Product Change Notice (PCN)

PCN Number: **PCN-0450952R-01**

Product(s) Affected: **PJ-025**

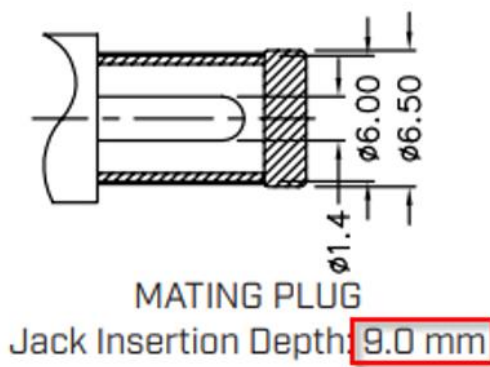
Description of Change: **Minor Housing and footprint differences. Material Change on the housing and terminals. See image Below**

PREVIOUS CUI DEVICES DETAIL / IMAGE			NEW CUI DEVICES DETAIL / IMAGE		
	MATERIAL	PLATING			
center pin	brass	tin	terminal 1	bronze t=0.50	silver
terminal 1	brass	tin	terminal 2	bronze t=0.25	silver
terminal 2	copper alloy	tin	terminal 3	brass t=0.40	silver
terminal 3	brass	tin	insulator	PA66 [UL94V-0]	black
plastic	PBT
